BURLINGTON DEVELOPMENT REVIEW BOARD

Tuesday August 5 2014, 5:00 p.m.

To: Development Review Board
From: Mary O'Neil, AICP, Senior Planner
Date: August 5, 2014
RE: ZP 14-1311SP, 86 Main Street

File: ZP 14-1311SP
Location: 86 Main Street
(northwest corner of Main and Pine Streets)
Zone: D Ward: 3
Date application accepted:
June 27, 2014
Applicant/ Owner: Tyler Scott
/ Grandview Farms, Inc.
Request: Sketch Plan review
for proposed twenty three unit
apartment building with office
space, 8 internal parking spaces.

③ WEST ELEVATION
1/8" = 1'-0"

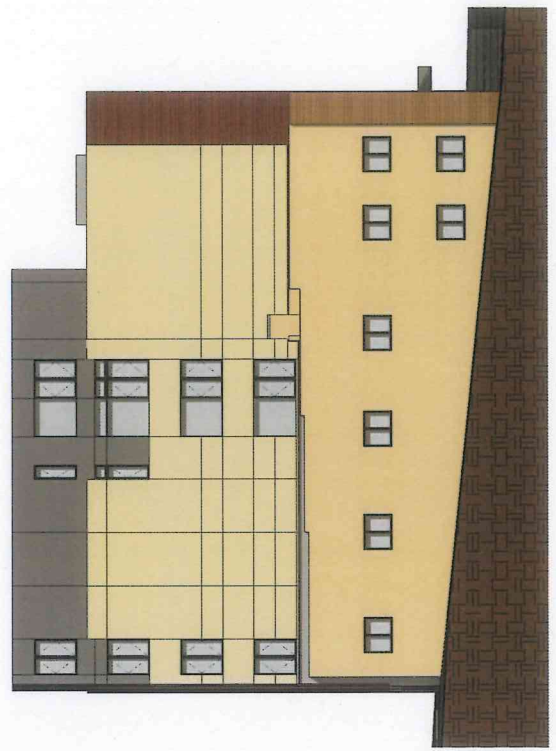
Elevations illustrate an intended setback from Main Street at 55' height. Main Street's ROW width is 99'. The setback from the front property line for the building above 55' should be at least 25% of that ROW width, not to exceed 40'. Although a required setback is noted on sixth floor plans, the measurement is not annotated. This measurement (minimally 24.75') should be annotated on the plans.

SITE
PLAN

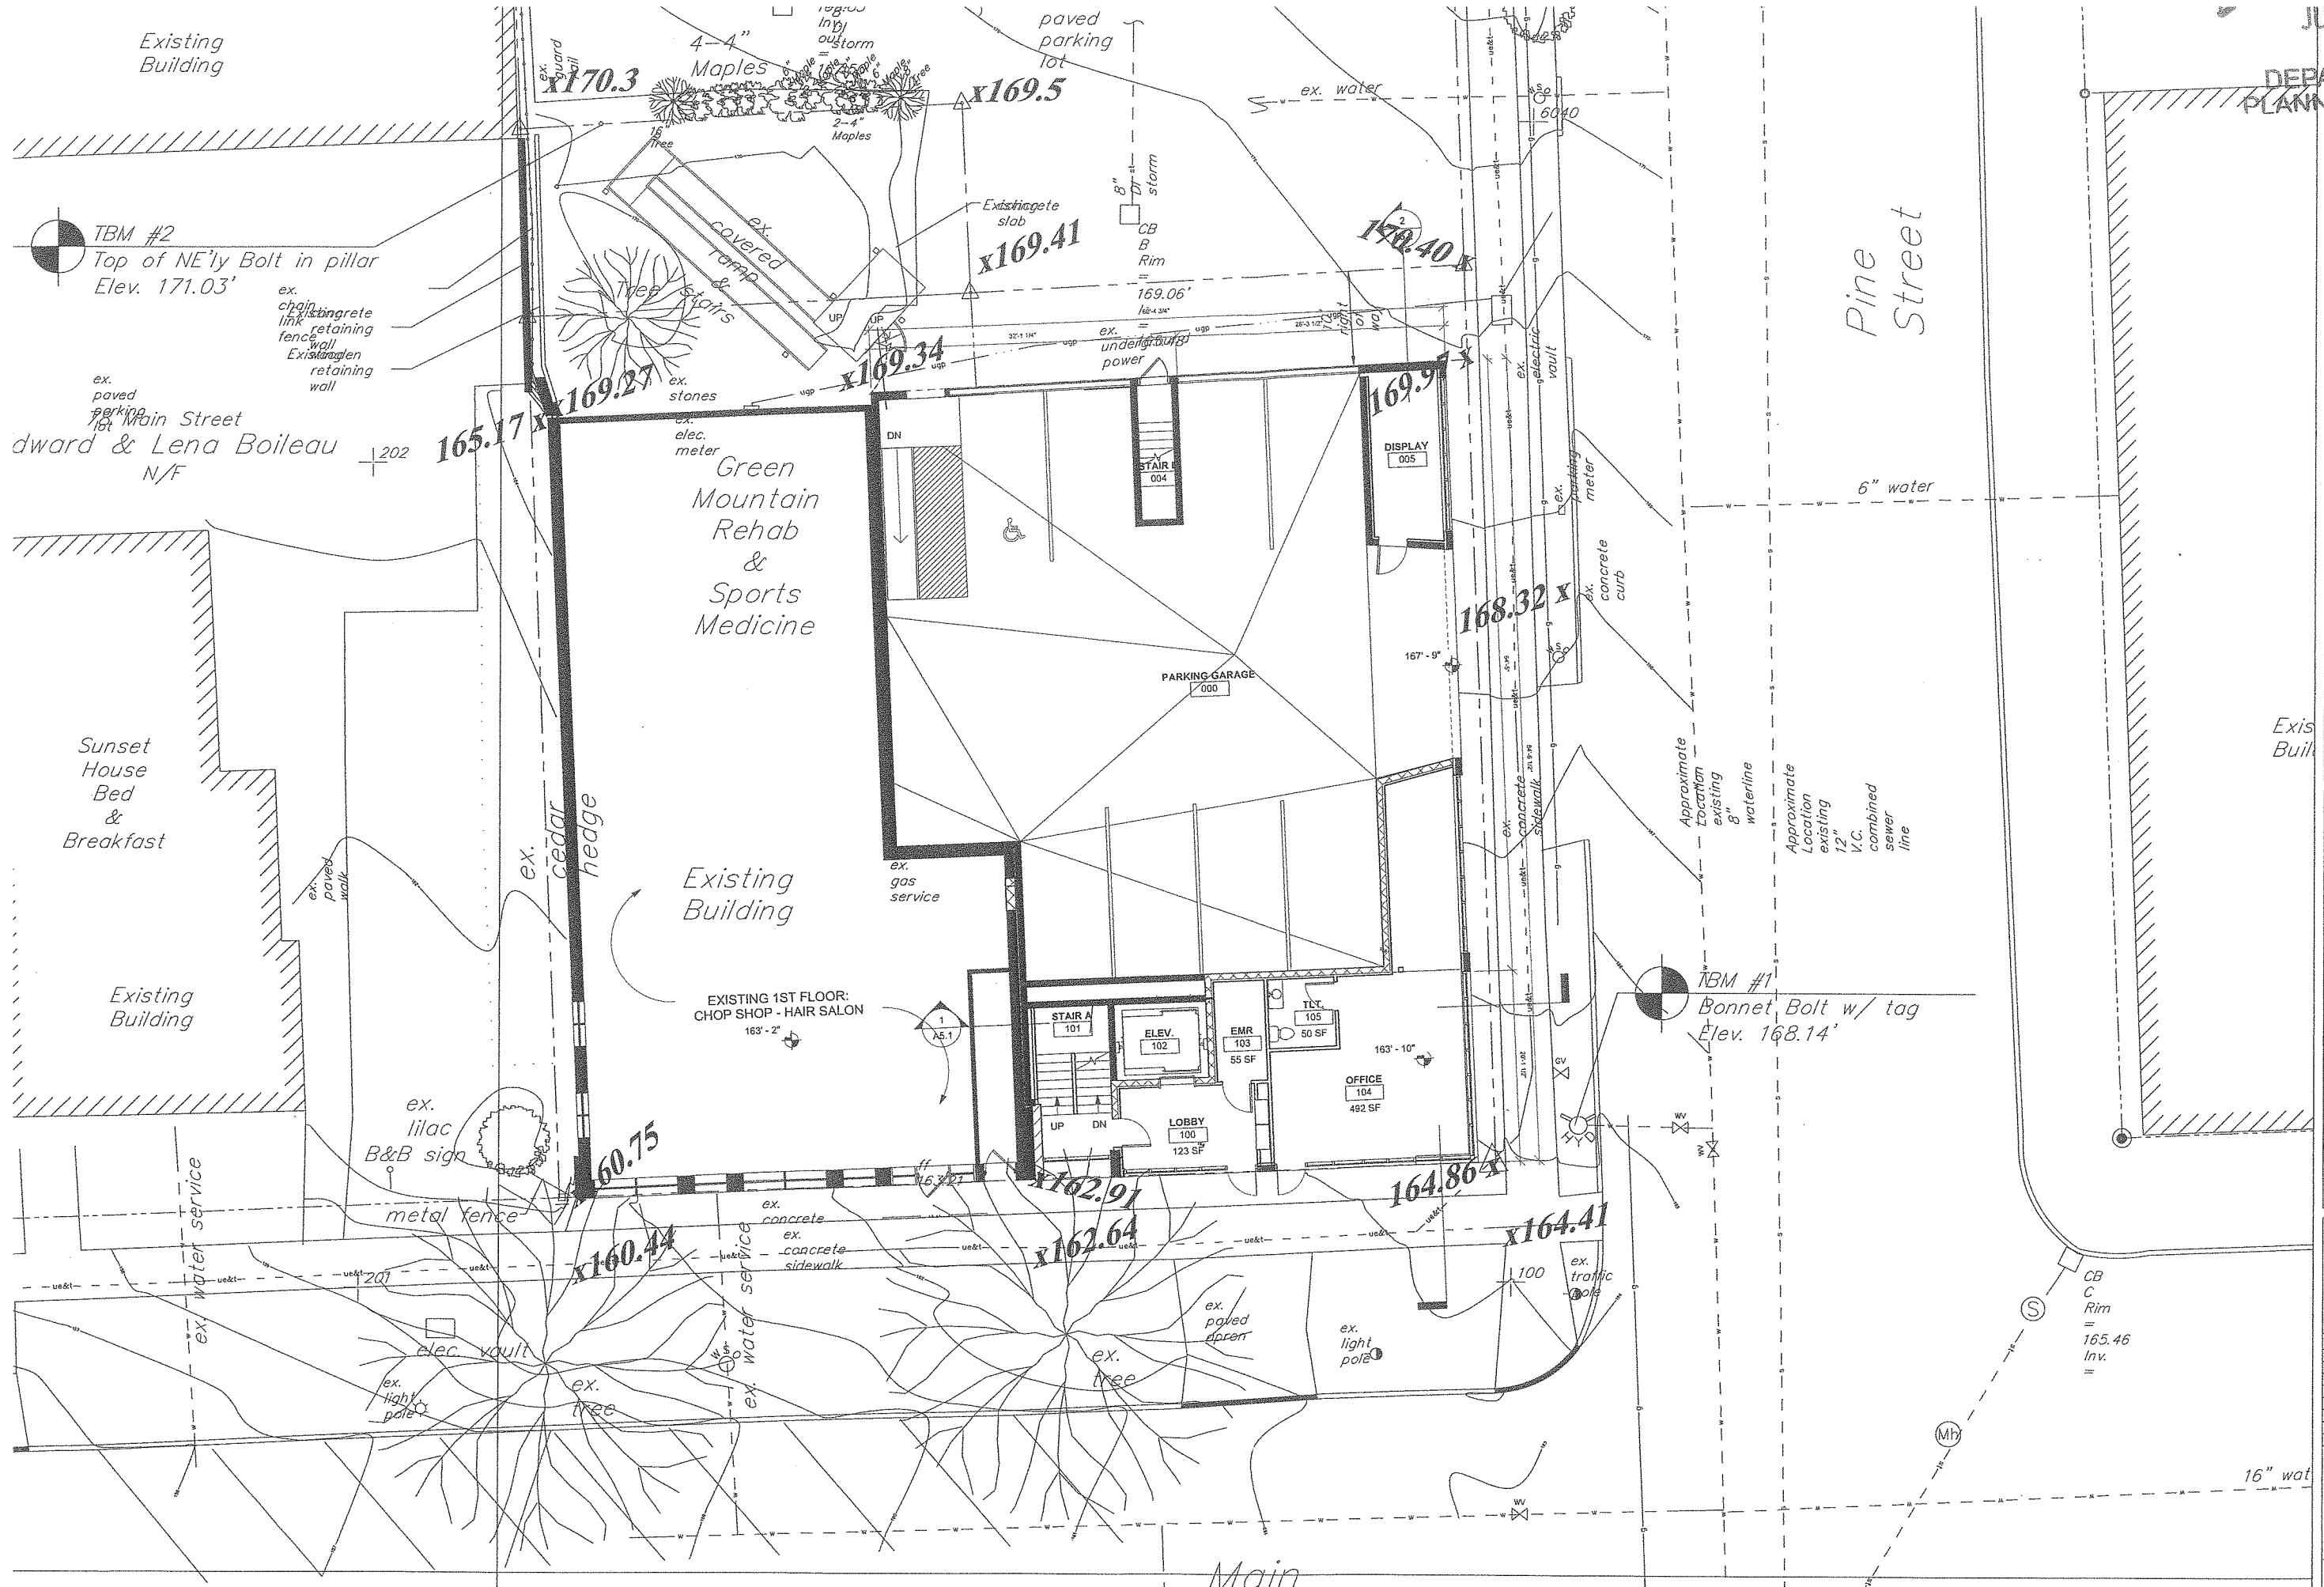
Max lot coverage permissible is 100%, with allowable setbacks of 0. (Although front setback is 12' from curb. There are 2 street frontages within this proposal.) Setbacks from the sidewalk are not annotated on the site plan, and must be to assure the required 12' from curbline.

This building is proposed to be attached to the existing 2 story building, so the only boundary line it approaches is on the north (Pine Street) side. The site plan identifies an existing 10' ROW. It is not clear who owns that ROW, but as presented, the building meets the required setback for abutting property.
